**To:** Richard Collier, McKim & Creed  
**From:** Brian Chambers, Senior Planner; 910.342.2782  
**CC:** File;  
**Date:** 12/30/2021  
**Re:** Center Point TRC Rev 2

Project Name: Center Point  
Response Date: 12/22/2021  
Reviewer: Eric Seidel, PE  
Department: Engineering – Plan Review Section

Project Name: **CENTERPOINT**

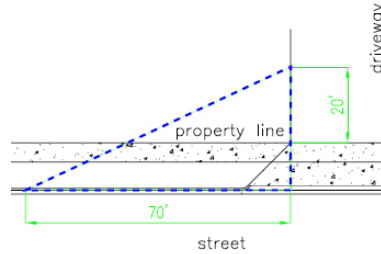
7. Show and apply the City's 20'x70' sight distance triangle at each driveway on the site plan and landscaping plan as per an image below. [Sec.18-529(c) (3) CofW LDC] [Sec. 18-812 CofW LDC]. [Sec. 18-667 Figure 18-667 CofW Updated LDC: Vision clearance].
